# **ADDENDUM**

#### ADDENDUM #4

Bid 20C10, Multi-Classroom Portable Unit for Oakdale Elementary School REVISED DUE DATE: Friday, April 24, 2020, prior to 2:00 P.M. at:

# Questions/Answers Bid 20C10, Multi-Classroom Portable Unit for Oakdale Elementary School

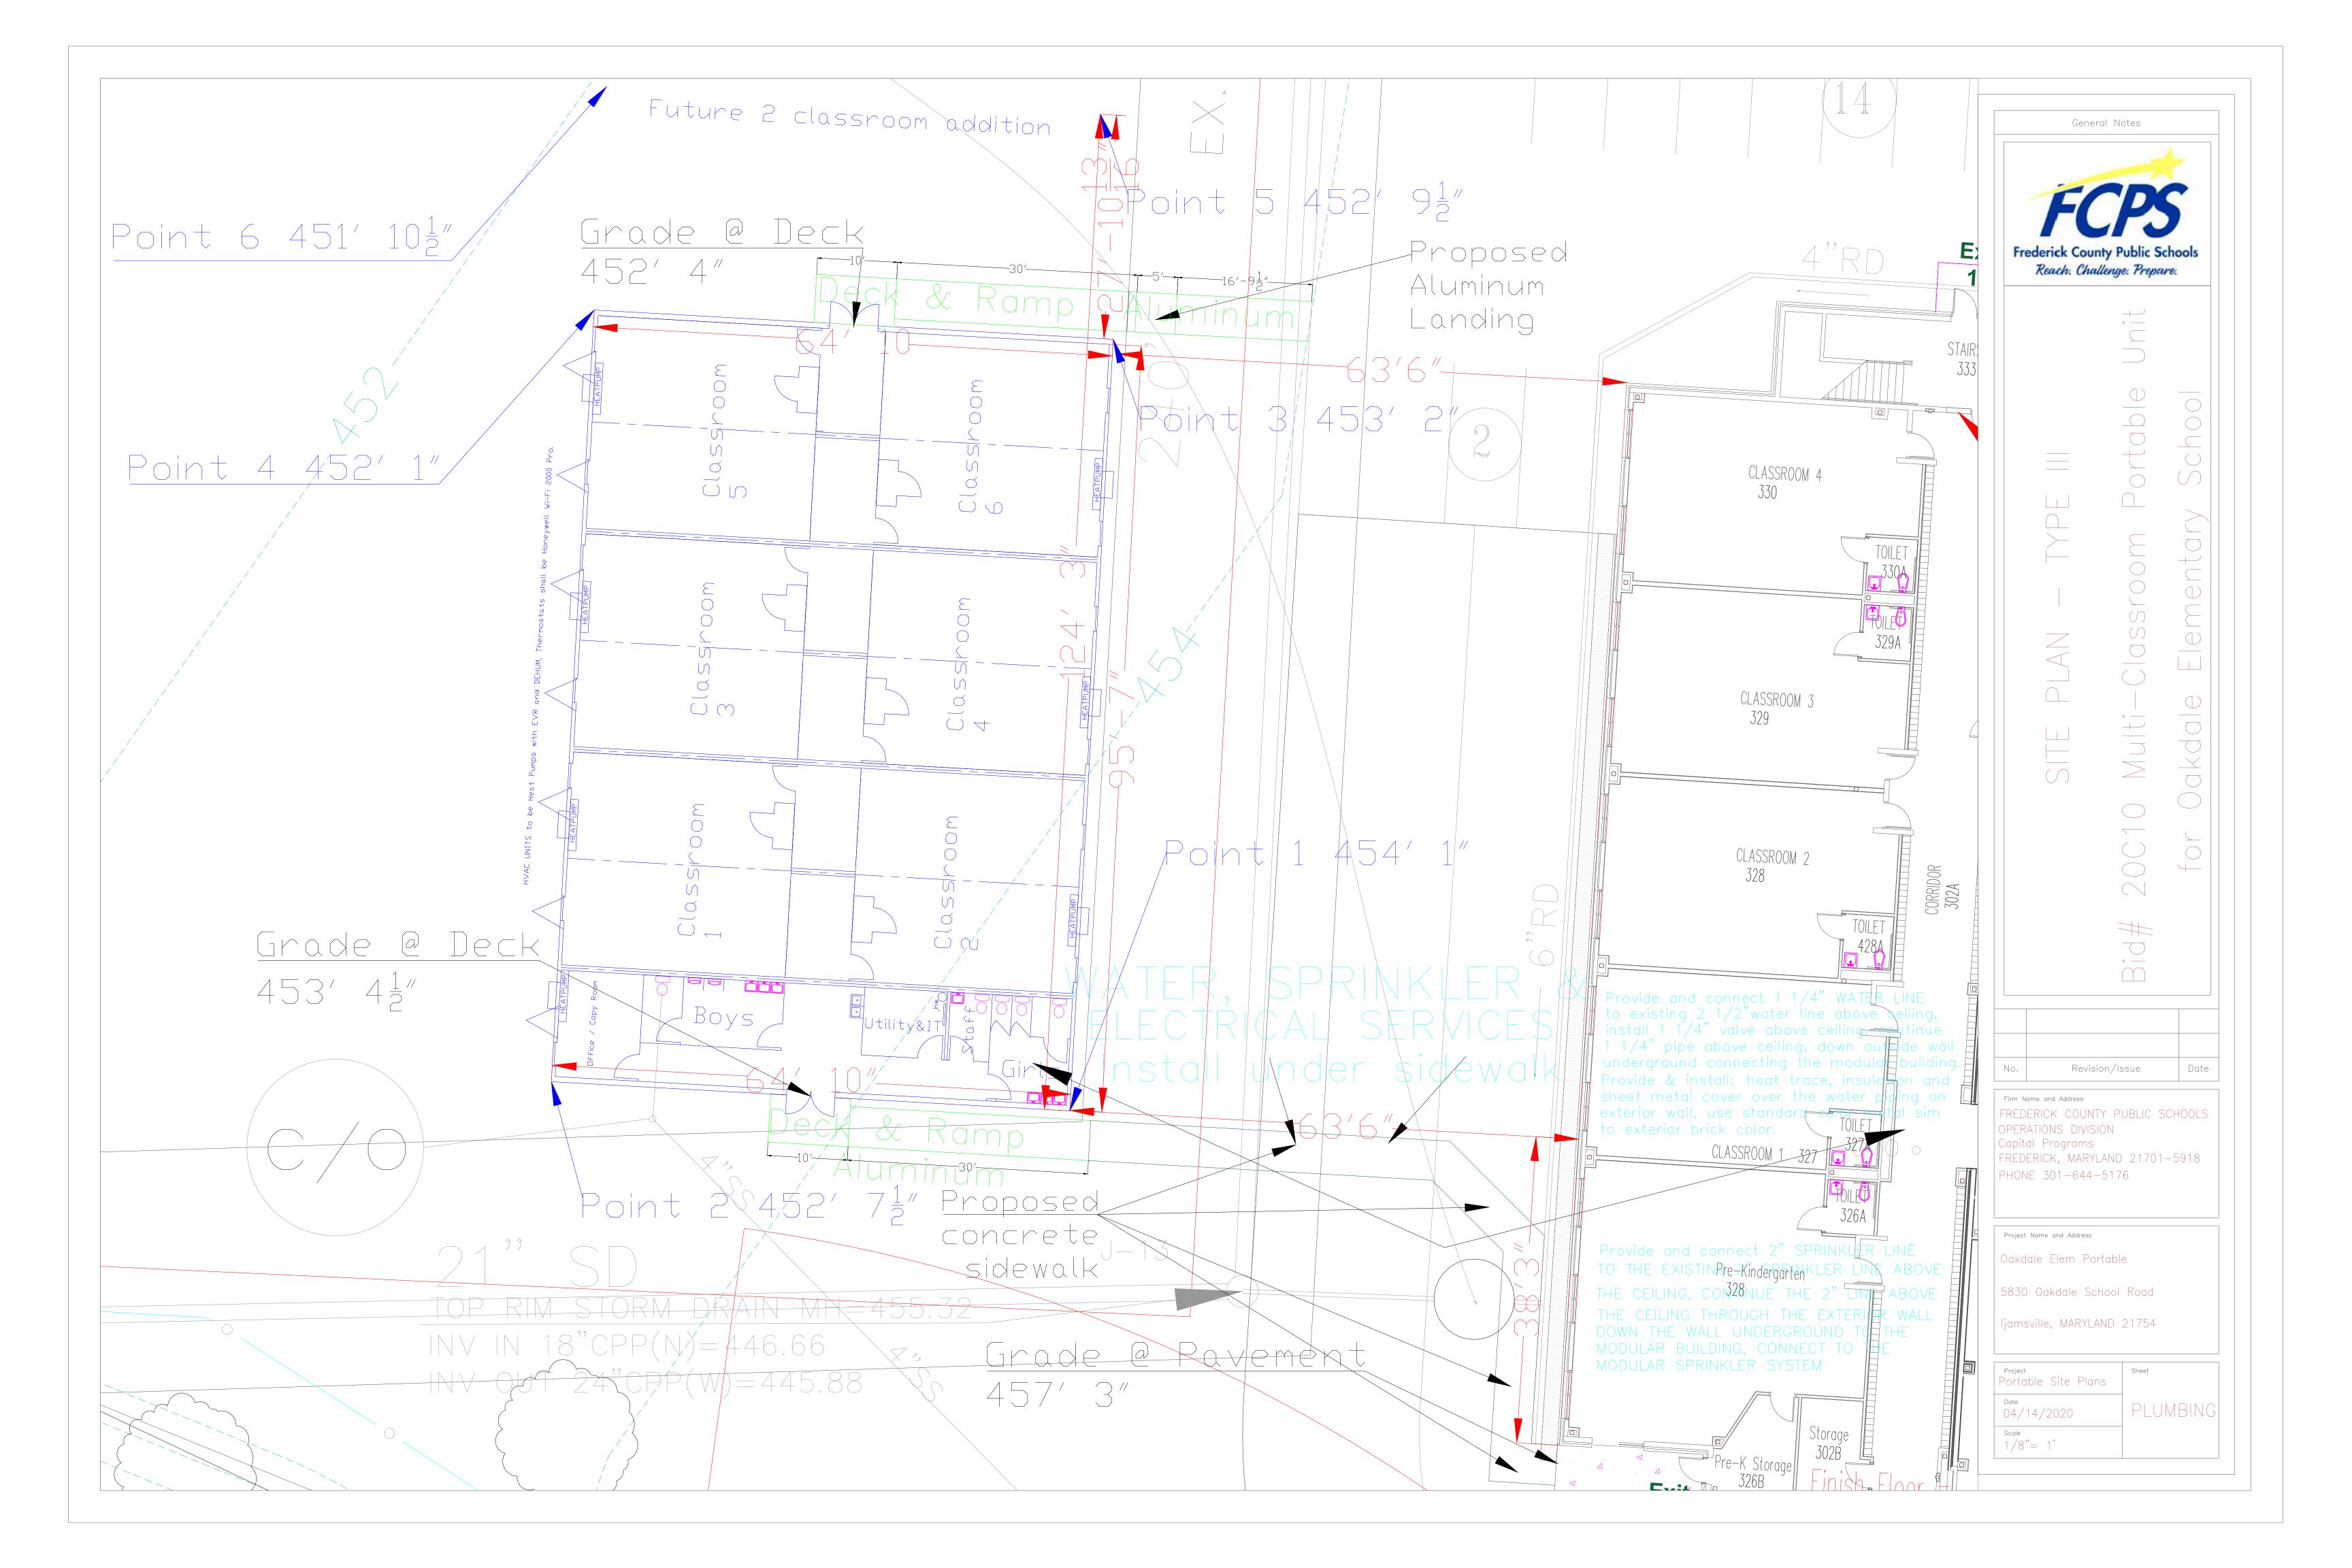
Question: Are we to assume 30' ramp will work at each of the two entrance ways?

Aluminum Ramps and Decks: Assume <u>one ADA compliant</u> <u>deck with not less than 30 feet of ADA ramp</u> to grade for building access. Assume a <u>second ADA compliant desk with one deck at exit doors and one switch back deck, a 30-foot section of ramp and a separate 15-foot section of ramp for building access. All decks and ramps shall be equipped with fall protection and hand rails.</u>

Response - An addendum is or will be issued showing the existing grade elevations and the deck ramp lengths identified in the document.
